# **A12 Chelmsford to A120 widening**

Development Consent Order Change  
Application Consultation

April 2023

Updated Junction 19 slip road design

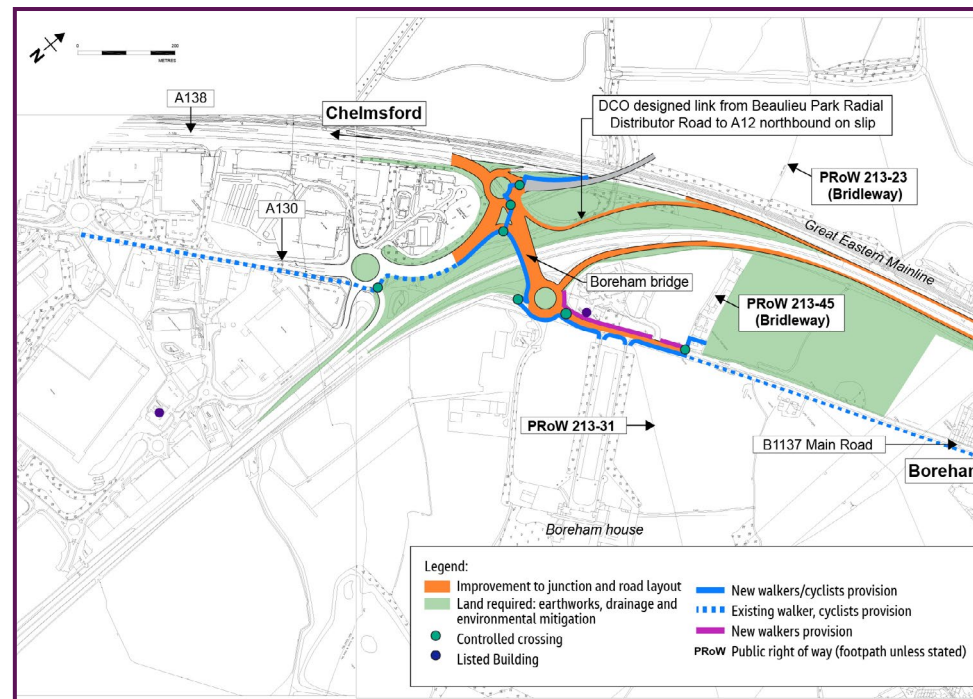
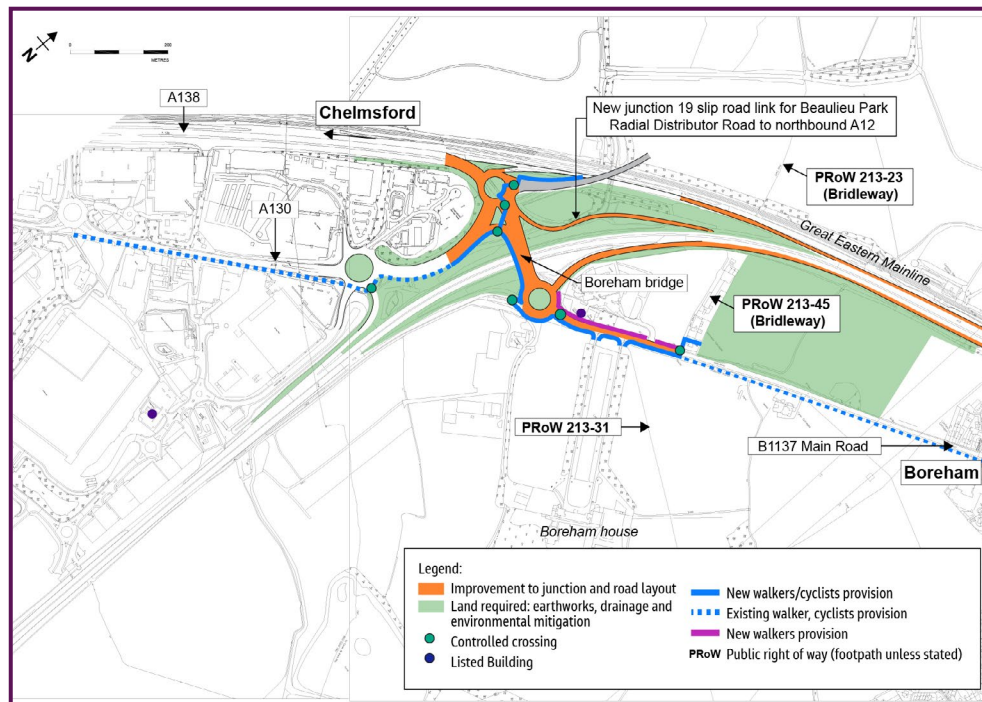
During our ongoing detailed design, we have identified a refinement to the design submitted as part of our DCO application, which further enhances the configuration of the northbound slip road at junction 19. This proposed segregated slip road merge improves the overall safety for road users.

The new design has the northbound slip road for traffic from the Beaulieu Park distributor road joining the A12 directly via its own slip road. This will be far enough from the existing slip road to ensure that overall the new design will improve safety for road users. There are no changes to the arrangement for walkers, cyclists or horse riders as a result of this change.

Updated Anglian Water Pumping Station design

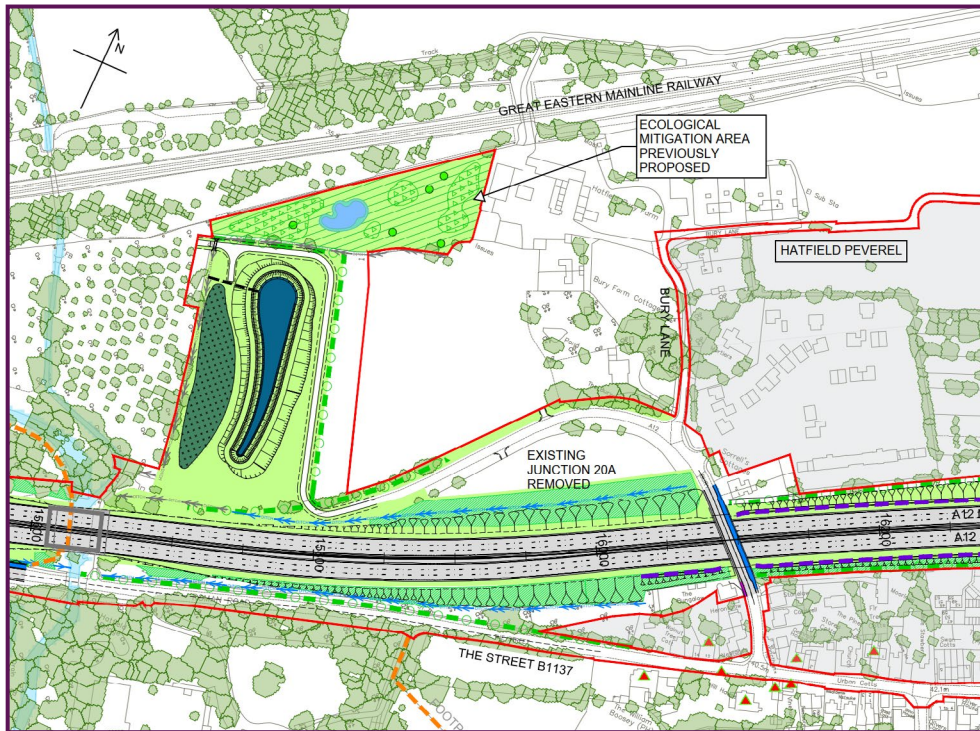
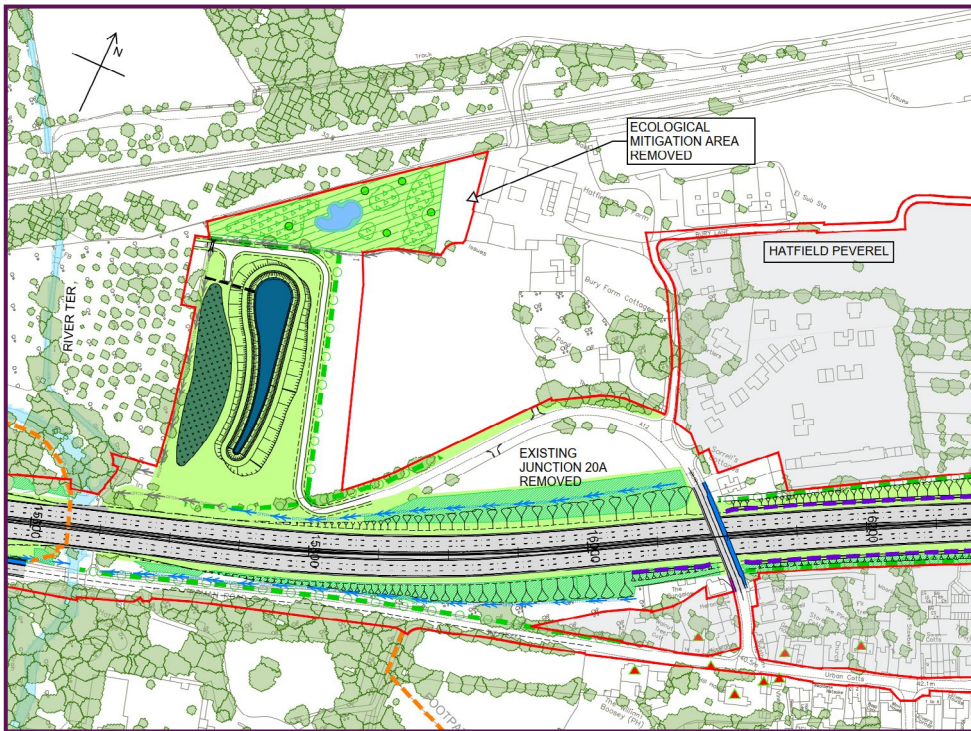
Since the DCO application was submitted, ongoing engagement has taken place with the local housing developer and the local authority. This engagement has identified that this land is needed for a waste water pumping station to be installed, as required by an approved planning application.

The location of this pumping station is within the ecological mitigation area proposed to provide habitat to reptiles. The pumping station is infrastructure required to facilitate this development for 50 homes.

To allow for the approved planning application we are now removing a small section of ecological mitigation as per the map below. The area of ecological mitigation lost decreases the reptile mitigation across the scheme by 0.4%. As the impact of this loss is negligible to the overall mitigation being provided, we do not need to replace this small loss of habitat.

This land will no longer be subject to compulsory or temporary acquisition powers.

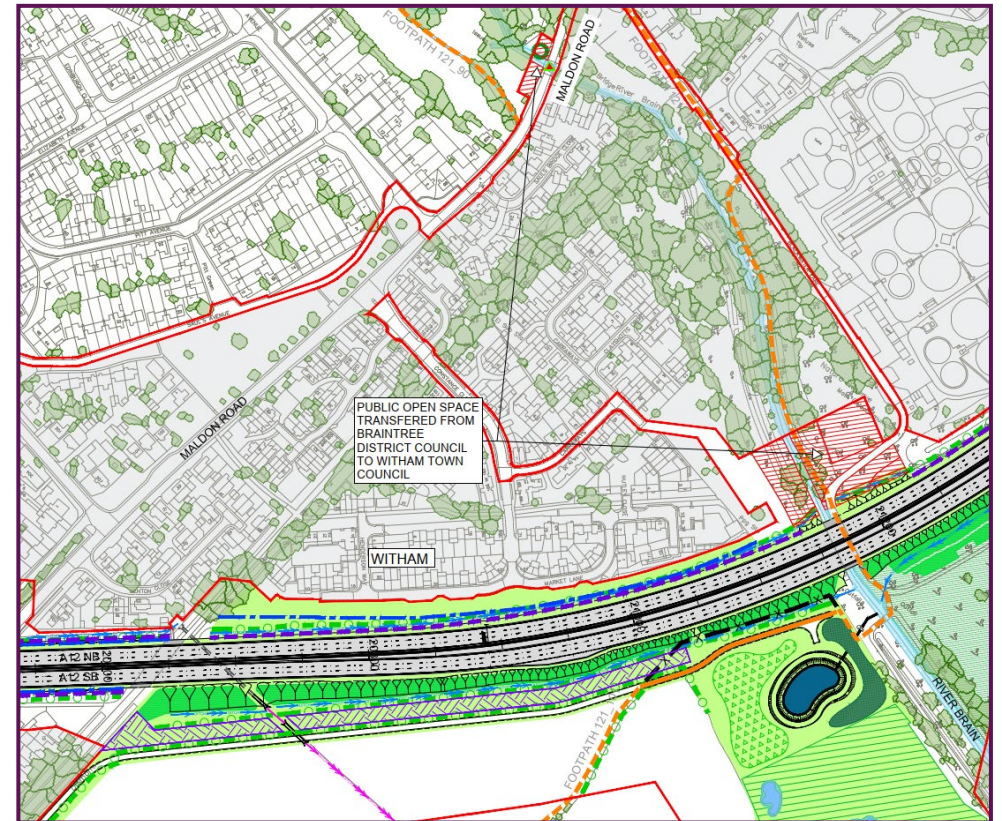
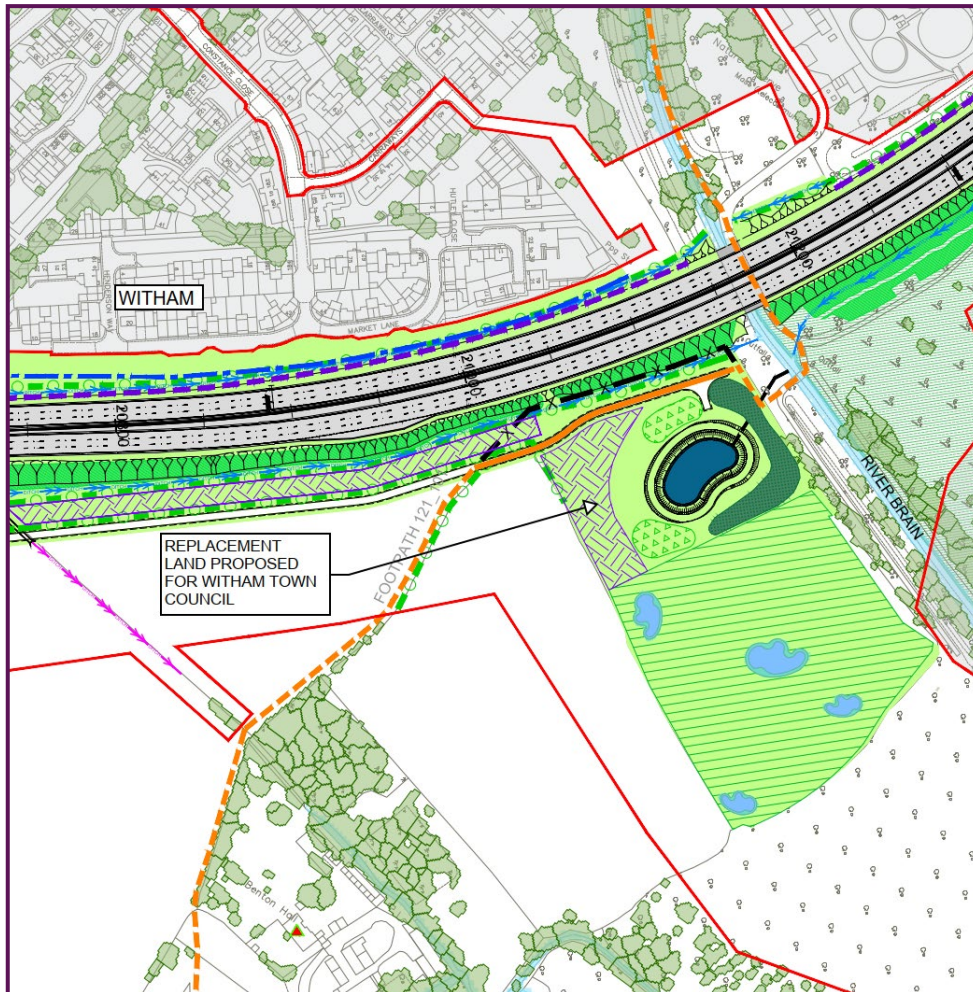
Engagement with the Town Council has continued since we submitted our application for development consent. During this engagement, and giving it further consideration, the Town Council concluded that the proposed replacement land was too isolated.

In addition, the Town Council was recently transferred land from Braintree District Council which was also impacted by the proposed scheme and would need to be replaced in agreement with the Town Council. The area of land transferred to the Town Council is shown in the map below.

The map below shows the agreed land to be provided to the Town Council to replace both areas of land being lost as part of the proposed scheme. The land is close to the Whetmead Nature Reserve and surrounds the proposed drainage pond.

Updated B1023 Flood Mitigation and Drainage design

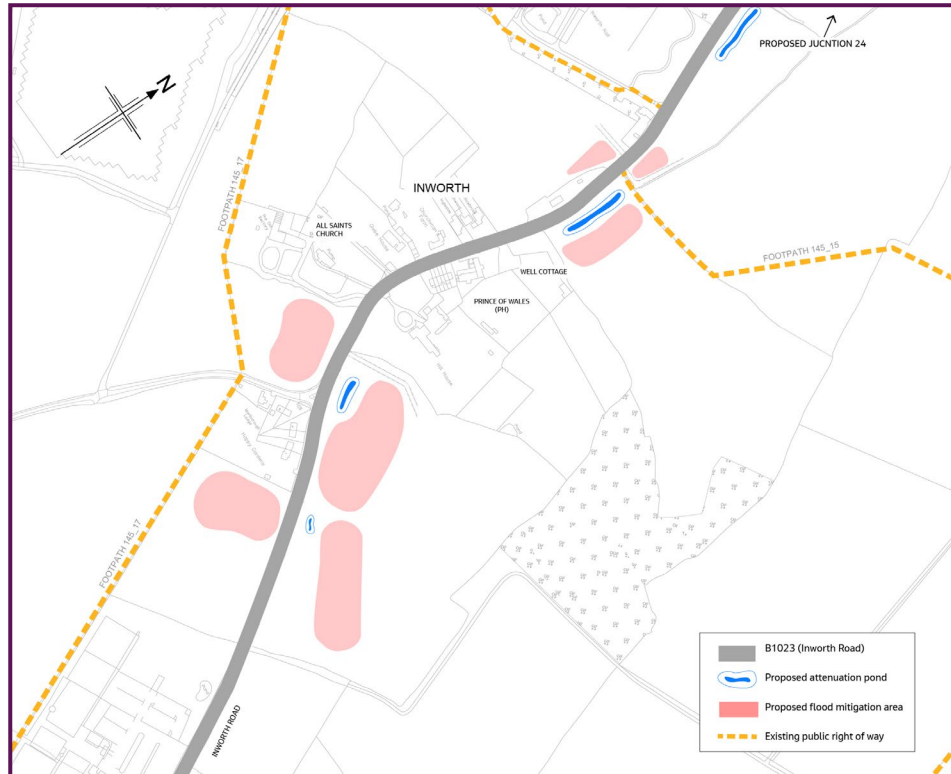
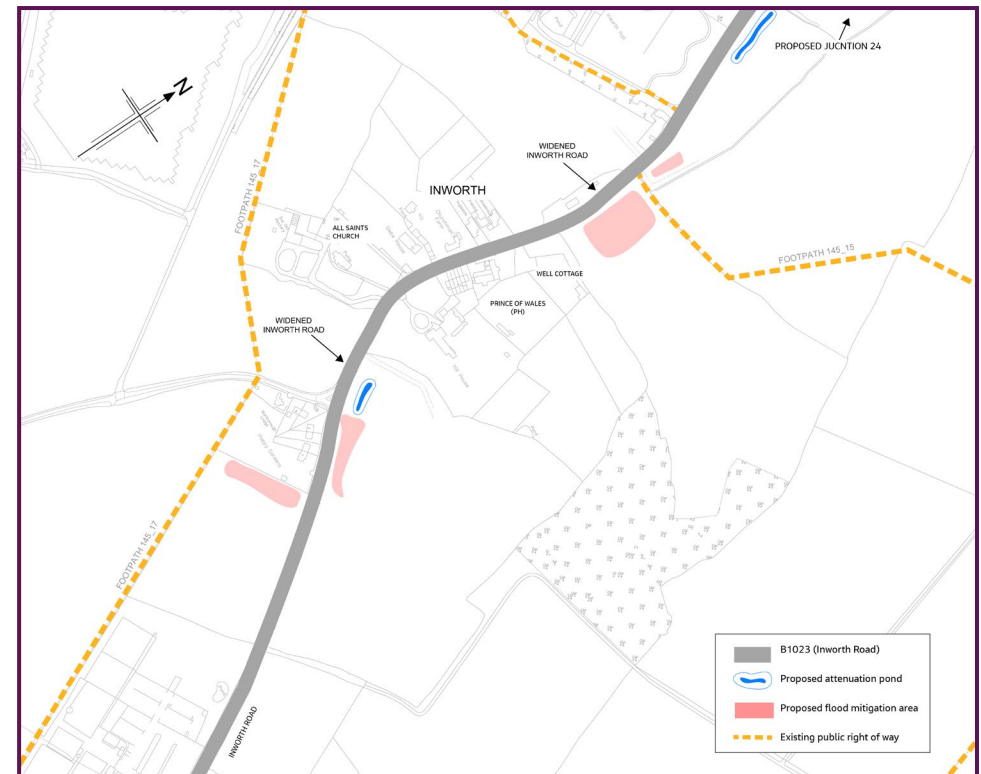
- Additional surveys and investigations, in particular of the existing drainage network, as well as utilities surveys.
- Hydraulic computer aided modelling of watercourses. A lack of available information on the existing drainage network meant that hydraulic modelling could not be undertaken for the design submitted at DCO, which was accordingly based on a worst case approach. With the additional information received, a hydraulic model has been built and used to refine the design of proposed flood mitigation measures.
- Further assessment of landtake in the area to address concerns raised by local stakeholders.
- Consideration of the existing high pressure (HP) gas main that crosses the B1023. The location of this gas main was not known at DCO submission and the initial design would have required excavation to take place over it.

As a result of new information available to the project such as site surveys and investigations, we are now able to present an updated design for the drainage ponds and flood mitigation areas alongside the B1023.

As a result of this, we have been able to reduce the number of drainage ponds from **four** down to **two**. We have also reduced the number of flood mitigation areas from **seven** down to **four**, and of those four two have also reduced in size.

This new design, shown on the map below, considerably reduces the number of ponds and flood mitigation areas required by the proposed scheme. It does however continue to ensure we achieve the policy requirements.

*Updated B1023 roundabout design*

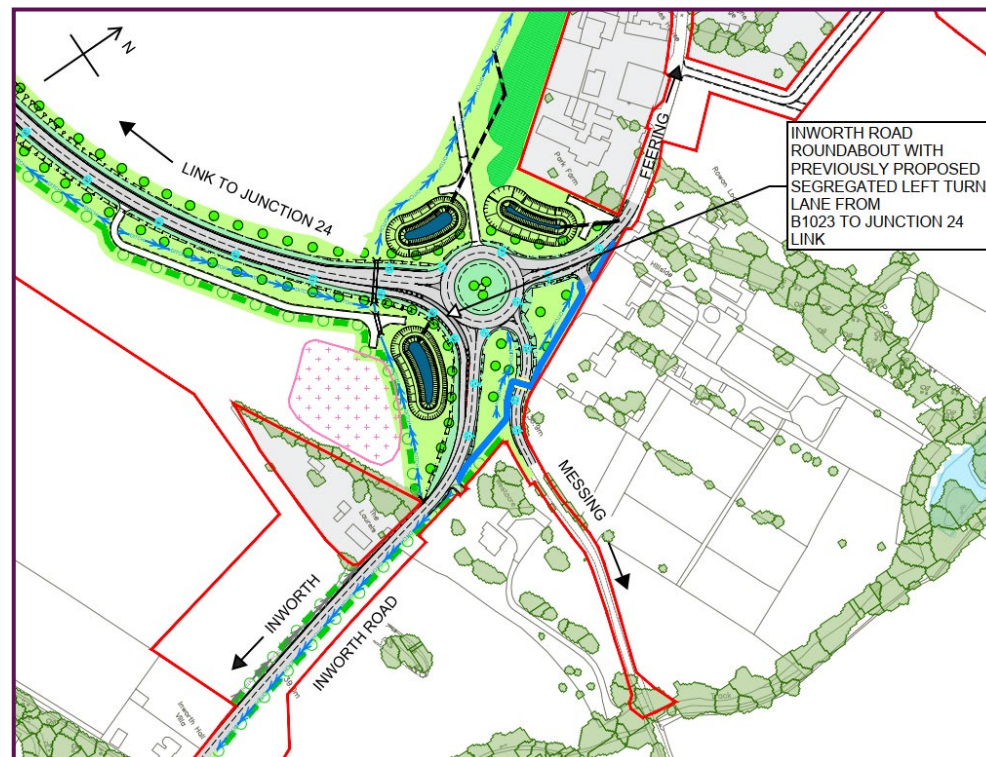
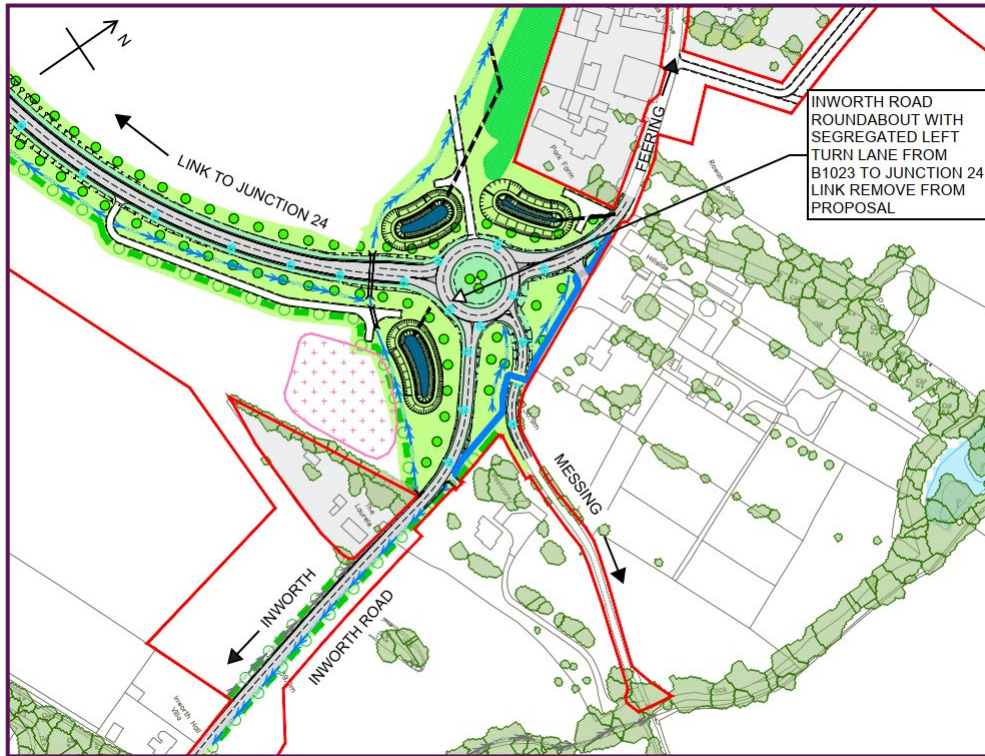
The SLTL was proposed to alleviate the potential queuing of traffic wishing to turn left from the B1023 south of the roundabout, by removing the conflict of this movement with drivers wishing to turn right at the roundabout from the B1023 north of the roundabout.

Through refinement of the design and validation against the strategic traffic model presented as part of the DCO Application, its inclusion is not required for the roundabout to perform acceptably in the proposed scheme's design year of 2042. Further to this, SLTLs are often associated with higher speed trunk road design, and the proposed removal of the SLTL helps reinforce the local nature of the existing B1023 in this area.

We are proposing to remove the segregated left turn lane (SLTL) from the arrangement of the B1023 roundabout. Traffic from Inworth Village will instead join the link road to junction 24 by utilising the B1023 roundabout. This will require traffic to give way to traffic already on the roundabout, as is the case with most roundabouts.

Updated junction 25 design

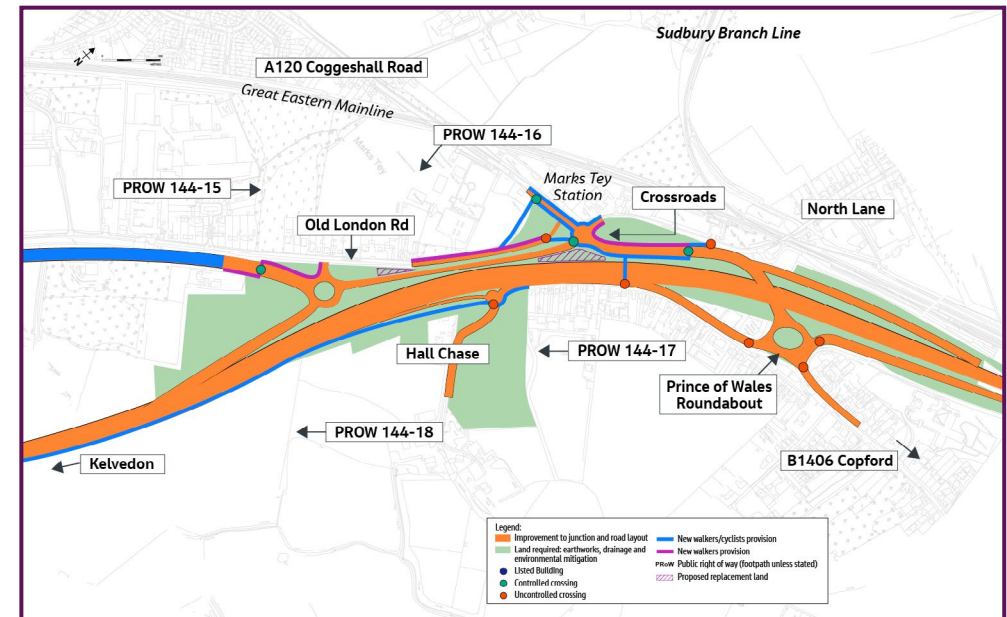
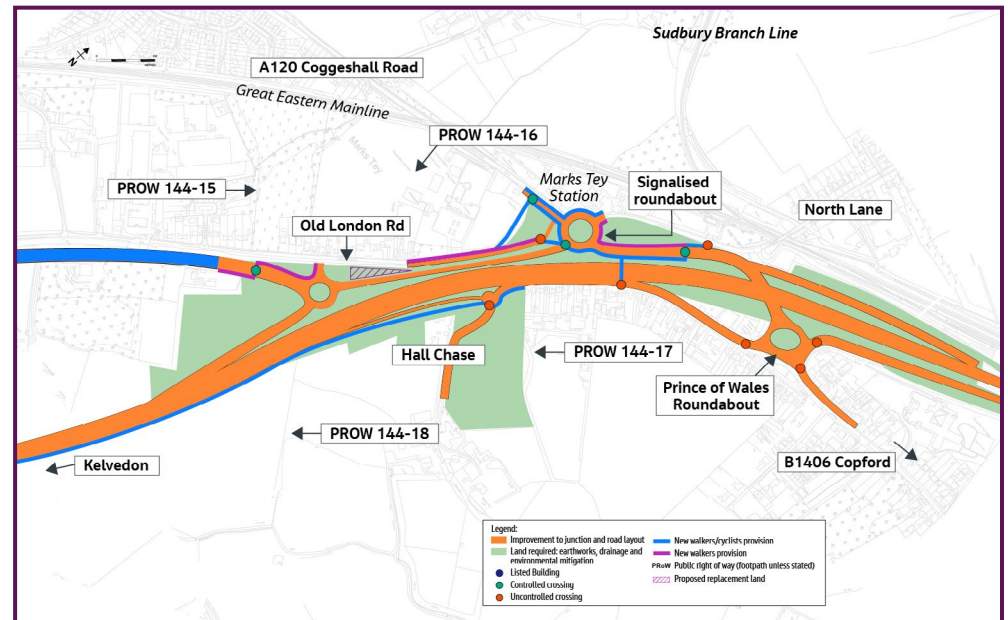
As part of the ongoing submissions from stakeholders, Marks Tey Parish council provided written representations reaffirming their position that the crossroads the scheme was proposing should be changed and instead the proposed scheme should aim to retain the existing roundabout. Further investigations of traffic data have shown that a roundabout, albeit with signals is able to accommodate the predicted traffic at this location.

Considering this further investigation, alongside the fact that retaining the roundabout would reduce land take, maximise the use of the existing infrastructure and make it possible to retain more of the existing vegetation we are proposing to amend our DCO design. This change also responds to the views expressed by the parish council.

Our new proposals see the Old Rectory roundabout maintained, which will become a partially signalised roundabout. This will maximise the existing infrastructure in the design and minimise tree loss within the Old Rectory roundabout island.
